***IN THE MATTER OF  
COMPLAINT AGAINST THE EL SEGUNDO  
ENERGY CENTER PROJECT***

**Docket No. 12-CAI-03  
Docket No. 00-AFC-14C  
Order No. 12-0912-03**

**COMMISSION ORDER ADOPTING THE SETTLEMENT AGREEMENT  
AMONG THE PARTIES TO THE COMPLAINT AGAINST THE EL  
SEGUNDO ENERGY CENTER**

### Joint Statement of Agreement

PROPOSED SOUTH SLOPE:  
**nrg**  
**301 VISTA DEL MAR BOULEVARD**  
**EL SEGUNDO ENERGY CENTER**  
 CITY OF EL SEGUNDO COUNTY OF LOS ANGELES STATE OF CALIFORNIA

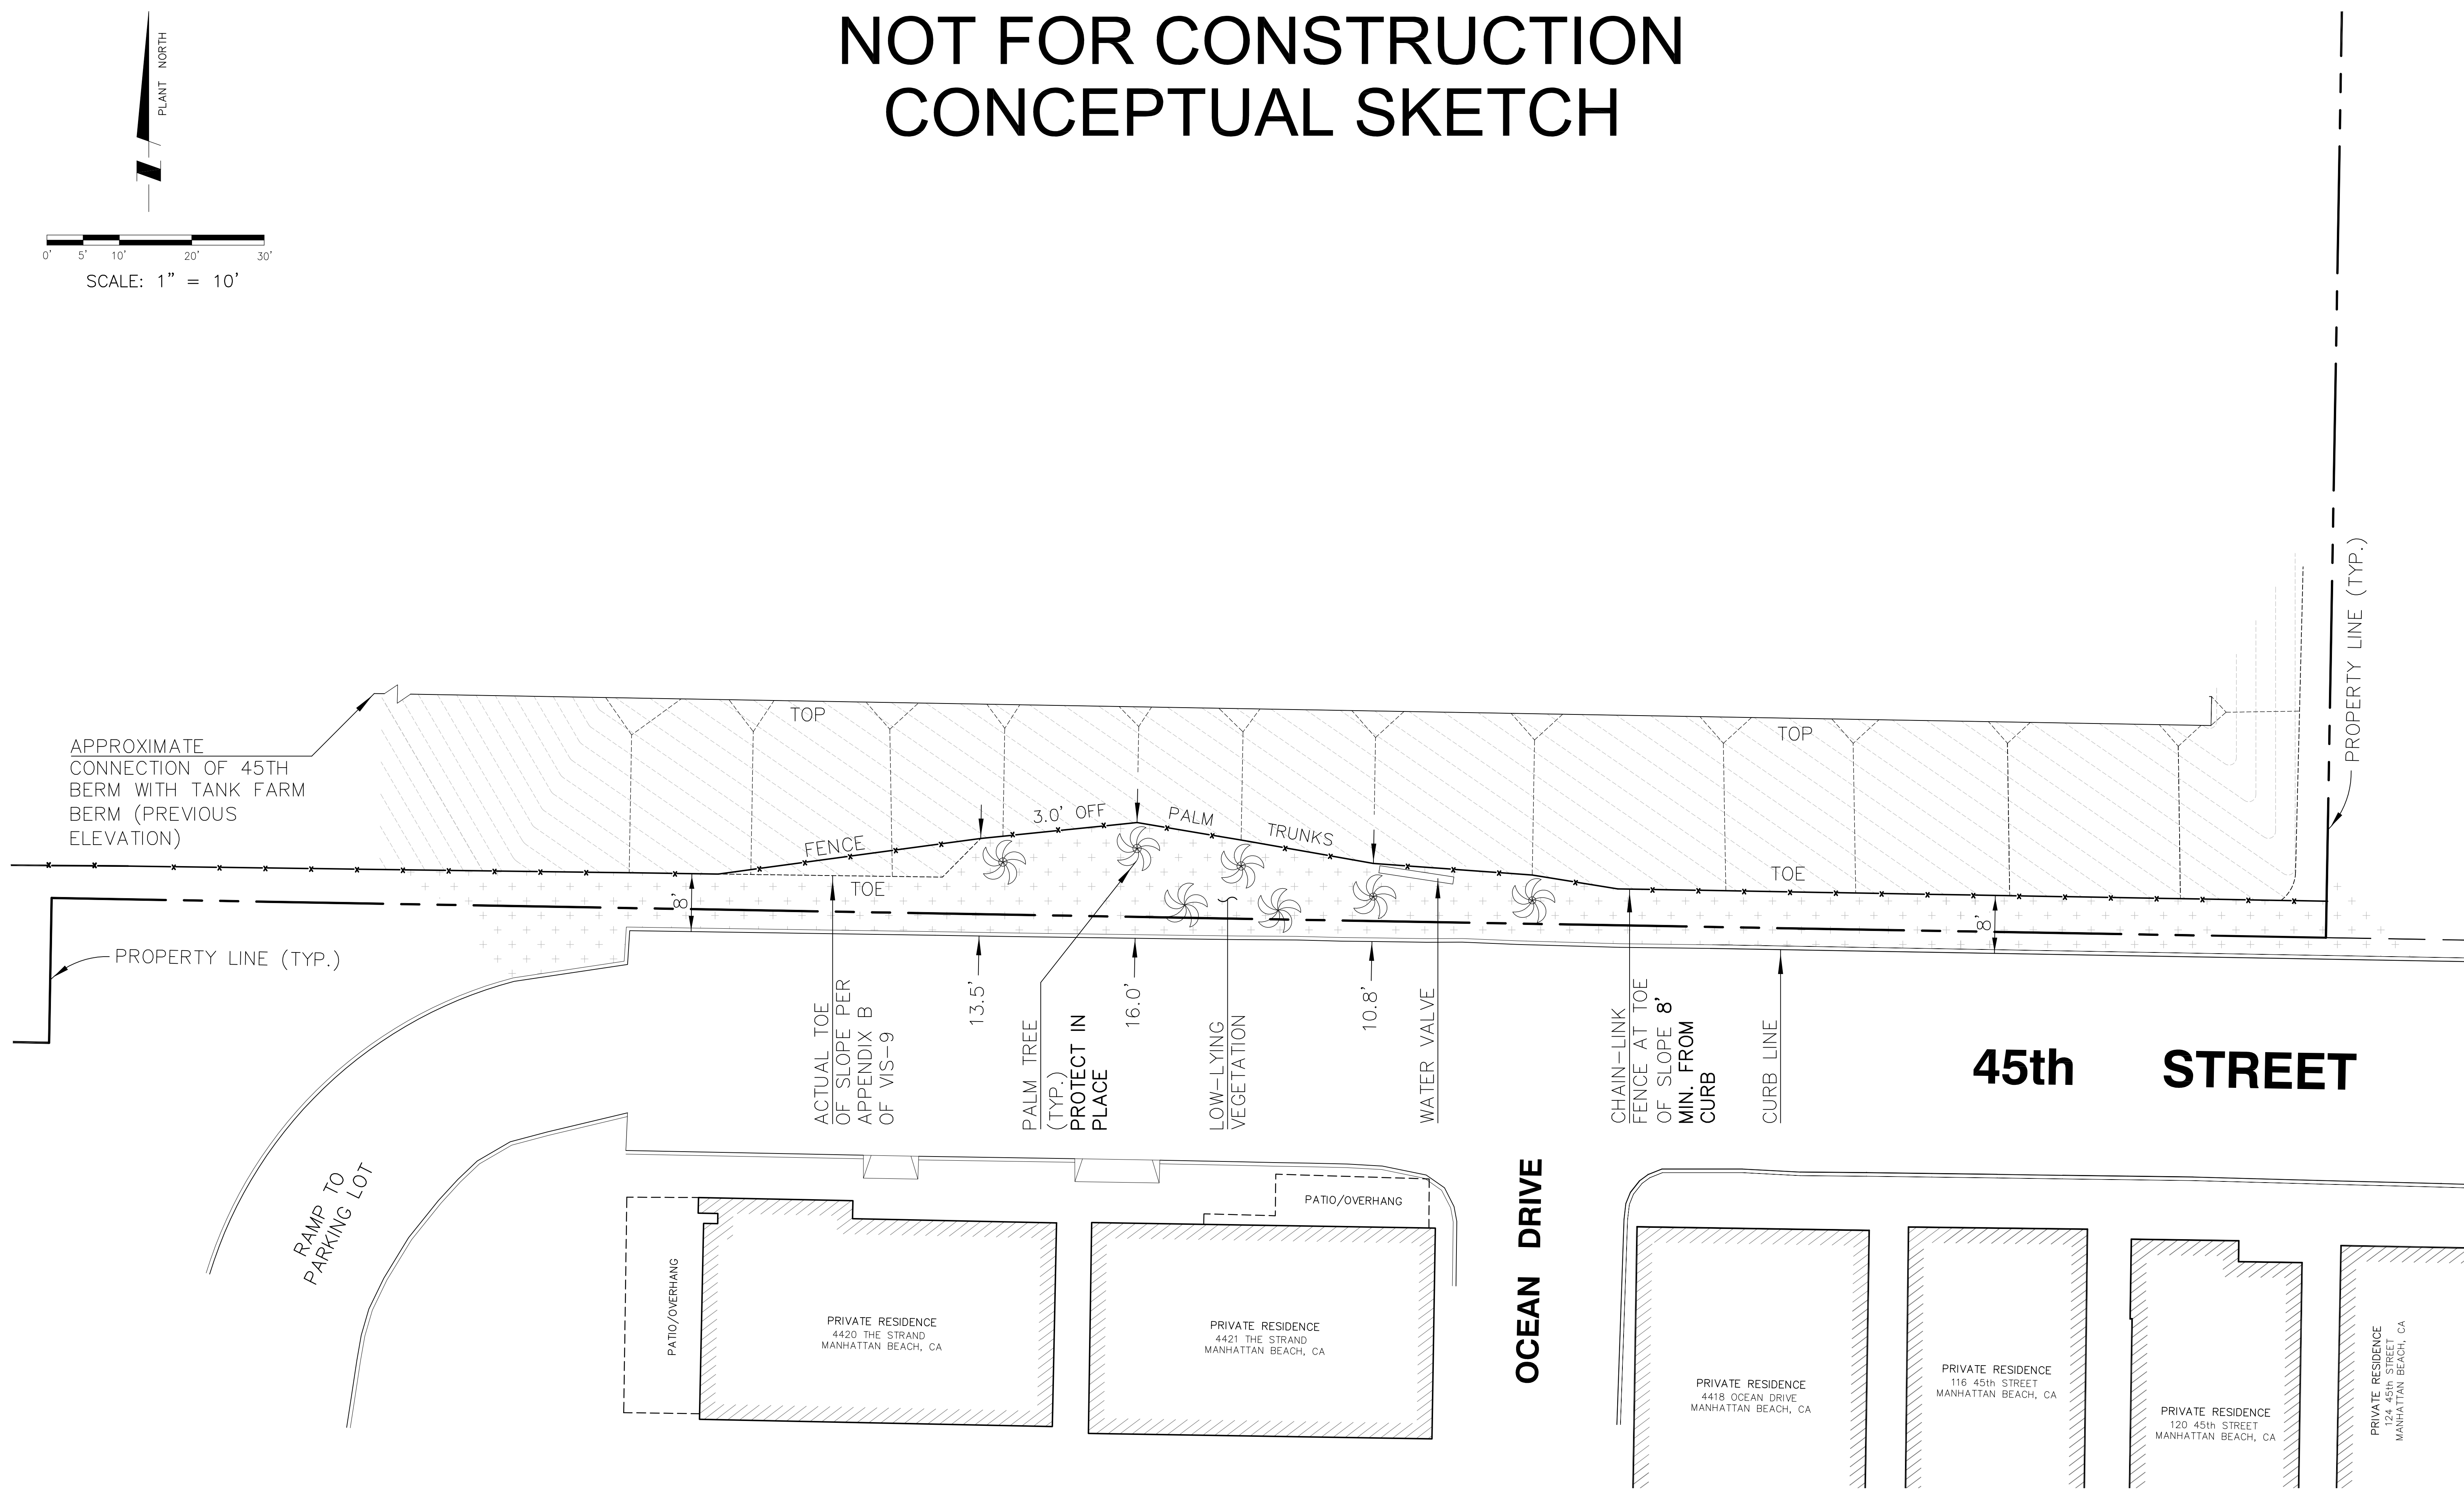
- a. The Parties jointly agree that the steepness of slope of the new 45th Street berm shall be increased in the area of the existing potable water valve and existing palm trees so the toe of the slope do not reach the trees and that the existing palm trees shall be retained and incorporated into the landscaping. A general depiction of intended location of the toe of the slope is provided in Attachment A to this document.

similar to historic fence location. The Parties recognize that the exact location of the fence was never strictly decided in the past and that documents differed on its location. The Parties also acknowledge that a temporary fence on the southern property line is necessary during construction of the southern area landscaping features but that it will be replaced with the permanent fence promptly upon completion of the landscaping along the southern perimeter. A general depiction of the intended location of the fence is provided in Attachment A to this document.

- 5) ESECL agrees to prepare and submit to the City of Manhattan Beach, the City of El Segundo and the Parties for comment and then to the Compliance Project Manager (CPM) for approval, a revised 45th Street Berm Drawing (Appendix B to the ***Temporary Landscaping and 45th St. Berm – Vis-9*** landscaping plan) that reflects the increased slope steepness to pull the slope back from the existing palm trees. The drawing should be consistent with the sketch provided as Attachment A.

- 6) ESECL agrees to prepare and submit to the City of Manhattan Beach, the City of El Segundo and the Parties for comment and then to the CPM for approval a revised sheet number 4 to Appendix A of the *Temporary Landscaping and 45th St. Berm – Vis-9* landscaping plan showing the revised berm slope and exact final location of the permanent fence along the southern property line. The drawing should be consistent with the sketch provided as Attachment A.
- 7) ESECL agrees the project is subject to the noise ordinances of the Cities of El Segundo and Manhattan Beach and affirms it will comply with those ordinances at all times.
- 8) Based on the foregoing agreement, the Parties jointly request the following:
  1. CEC staff concurrence with this agreement and
  2. an order from the CEC resolving the Complaint that directs ESECL to conform to the terms of this agreement.
